PROPOSAL FOR DRAFT AMENDMENTS TO REGULATION NO. 50
 (Position, stop and direction indicator lamps for motorcycles)
 (transmitted by the expert from IMMA)

A. PROPOSAL

Maximum and Minimum intensity on the H-H line specified in Regulation No. 50-00 S4

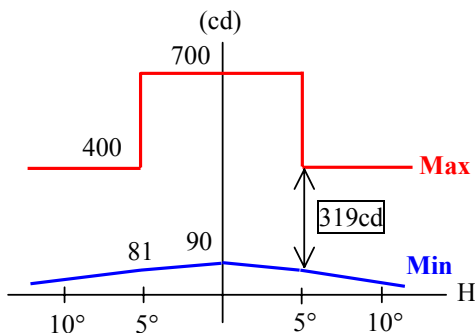
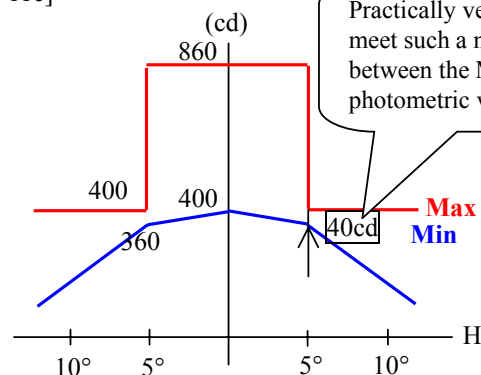
Practically very difficult to meet such a narrow range between the Min. & Max. photometric values.

Current ECE Regulation No. 50;

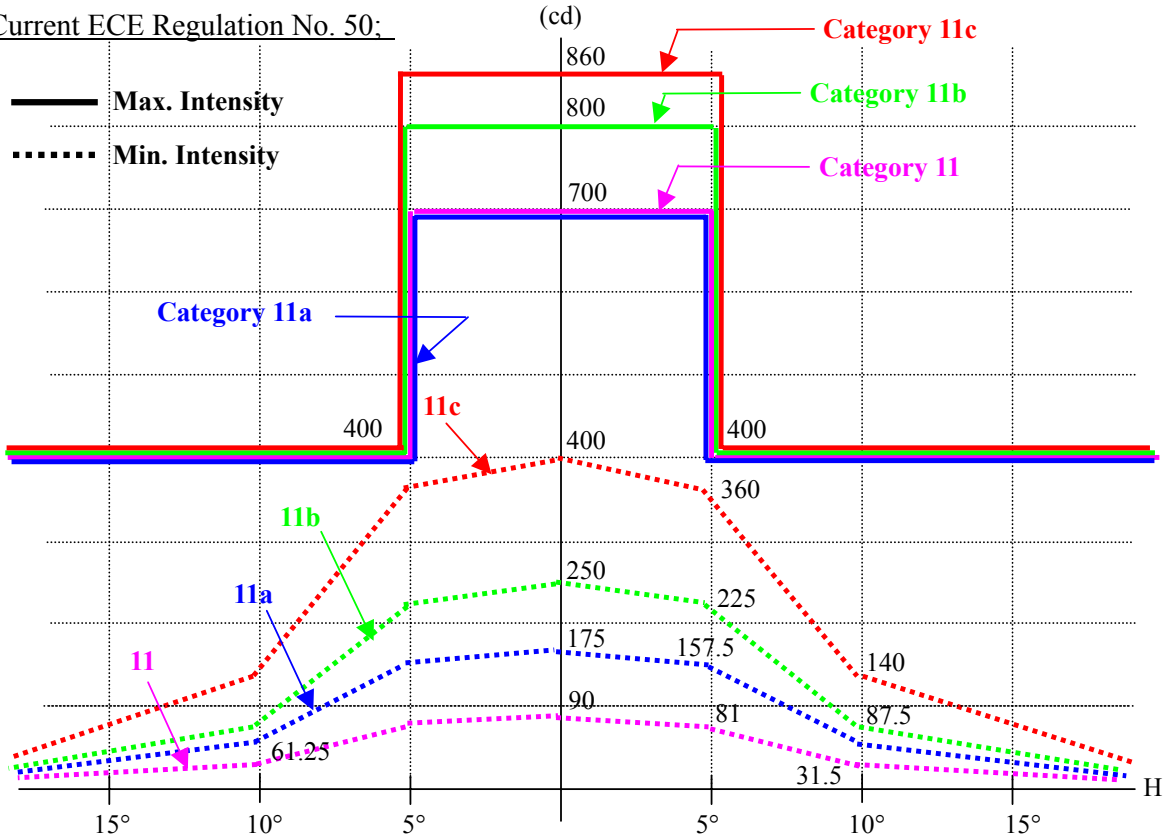
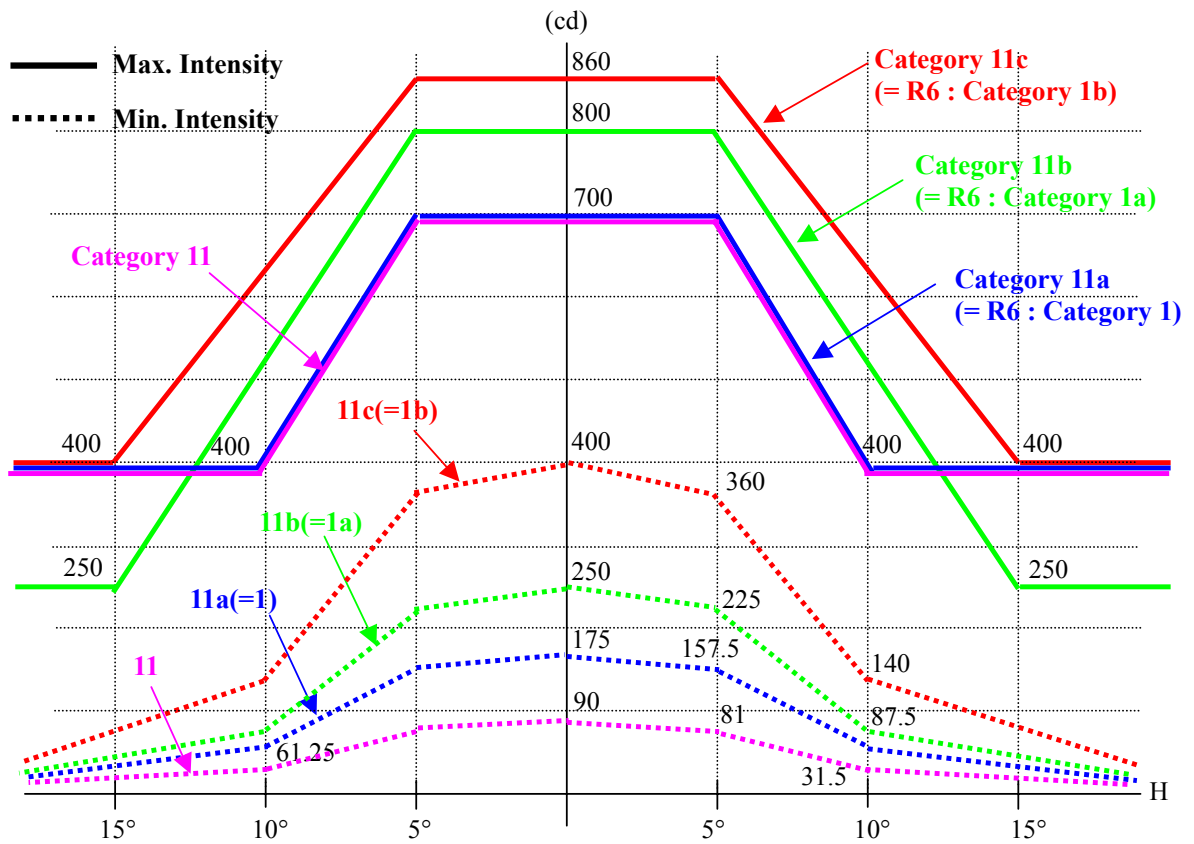
- (1) delete of the maximum intensity of 400cd to outside of the zone defined by the +/- 5 degrees H and +/- 10 degrees V
- (2) provide the new maximum intensity requirement to the outside the zone defined by the +/- 10 degree H and +/- 10 degree V (10 degrees-field).
- (3) Between the boundaries of the 10 degrees-field and the 5 degrees-field (+/- 5 degrees H and +/- 5 degrees V), the maximum values are increased linearly up to the 700cd.

- (1) delete of the maximum intensity of 400cd to outside of the zone defined by the +/- 5 degrees H and +/- 10 degrees V
- (2) provide the new maximum intensity requirement to the outside the zone defined by the +/- 15 degree H and +/- 15 degree V (15 degrees-field).
- (3) Between the boundaries of the 15 degrees-field and the 5 degrees-field (+/- 5 degrees H and +/- 5 degrees V), the maximum values are increased linearly up to the 800cd(category 11b) or 860cd(category 11c).

Category	H-V point Min. intensity (cd)	Max. intensity(cd)	
		Area	1 light source
11	90 *1	inward of H= \pm 5 deg, V= \pm 5 deg	700
		outward of H= \pm 10 deg, V= \pm 10 deg	400
11a	175 *1	inward of H= \pm 5 deg, V= \pm 5 deg	700
		outward of H= \pm 10 deg, V= \pm 10 deg	400
11b	250 *1	inward of H= \pm 5 deg, V= \pm 5 deg	800
		outward of H= \pm 15 deg, V= \pm 15 deg	250
11c	400 *1	inward of H= \pm 5 deg, V= \pm 5 deg	860
		outward of H= \pm 15 deg, V= \pm 15 deg	400
